SUBJECT: Submits response to request for addl info re individual plant exam for plant, per GL 88-20.

**Subject: WNP-2, OPERATING LICENSE NPF-21
RESPONSE TO REQUEST FOR ADDITIONAL INFORMATION
RELATED TO INDIVIDUAL PLANT EXAMINATION FOR
WASHINGTON PUBLIC POWER SUPPLY SYSTEM (WPPSS)
NUCLEAR PROJECT NO. 2 (WNP-2)**

**RESPONSE TO REQUEST FOR ADDITIONAL INFORMATION RELATED TO
INDIVIDUAL PLANT EXAMINATION FOR WNP-2**

LOSS OF FEEDWATER EVENT TREE

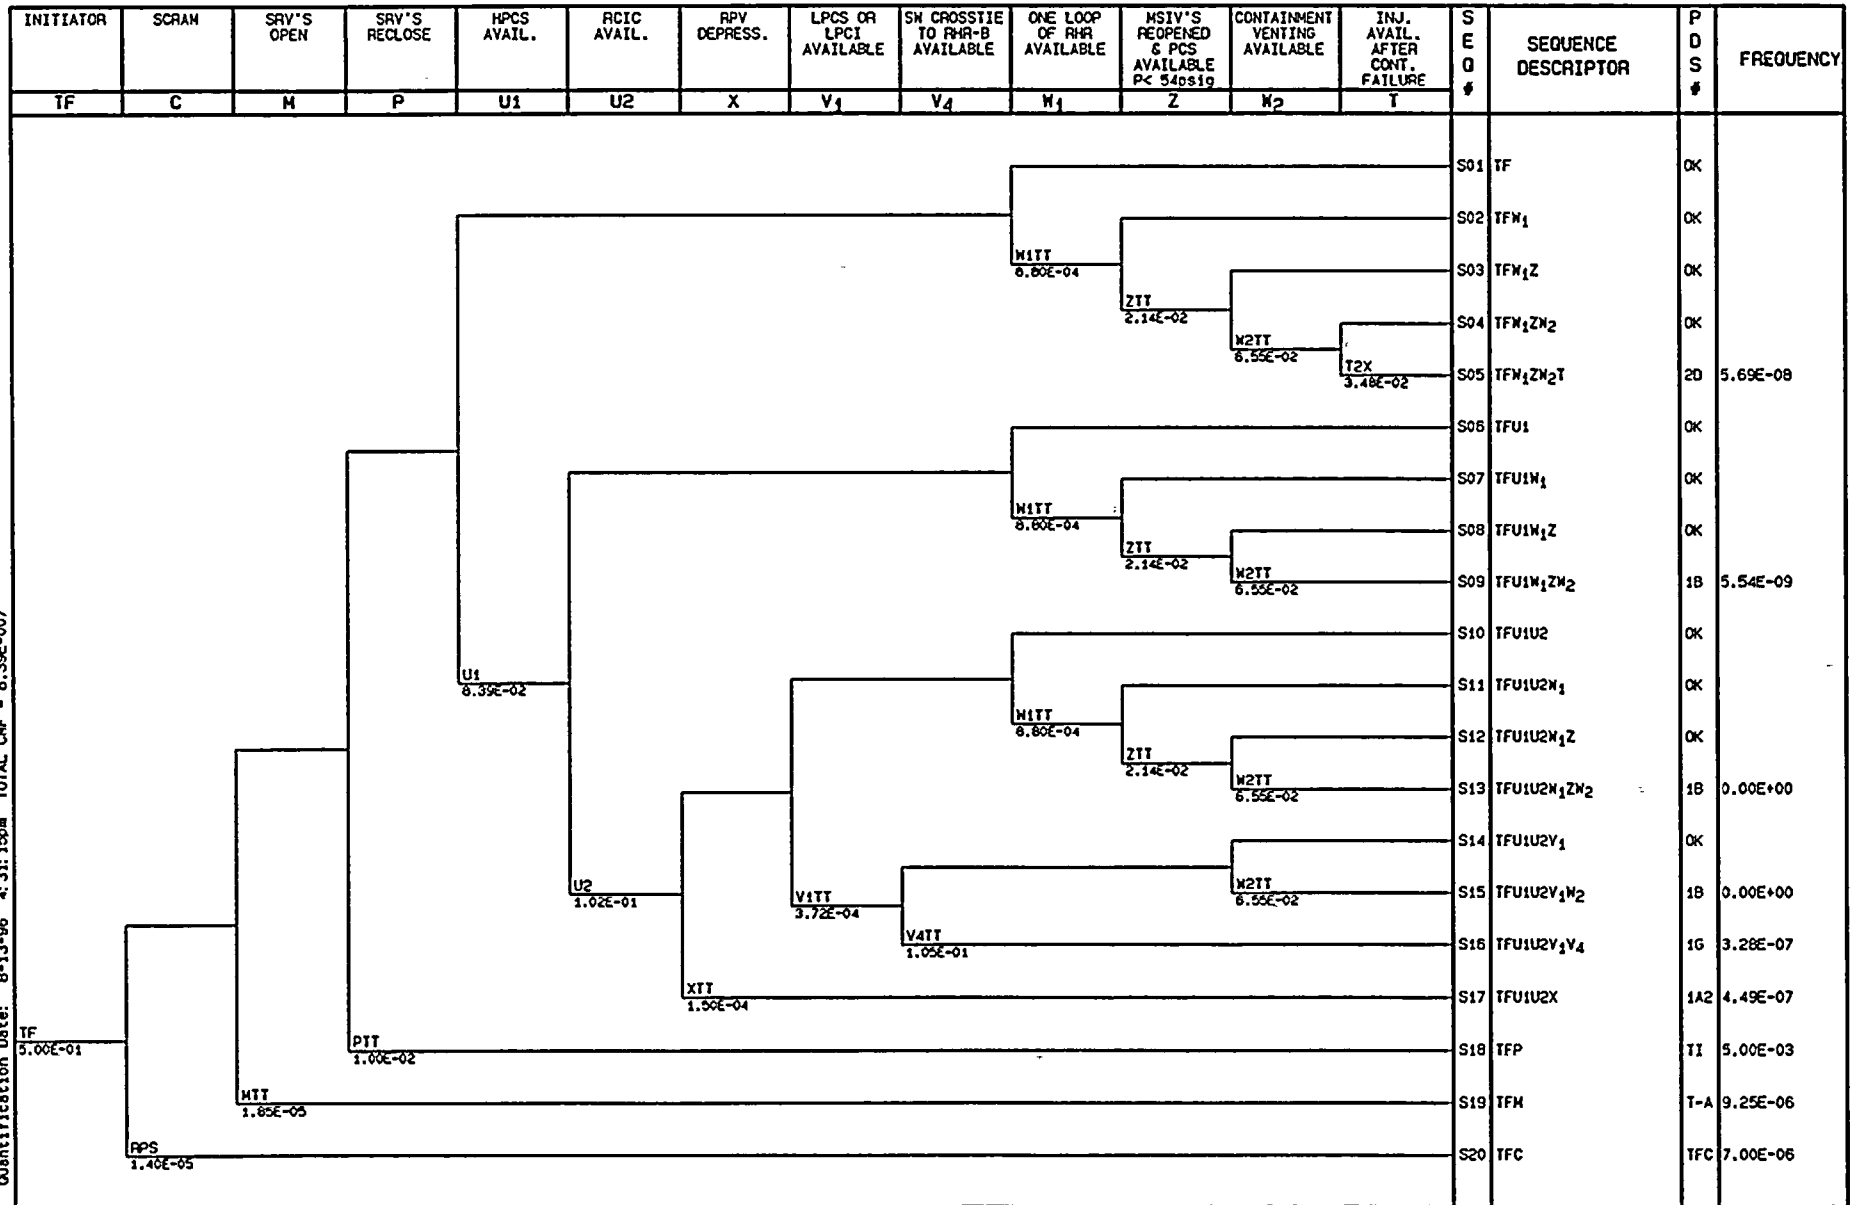
The event trees for TE, TT and TF are attached.
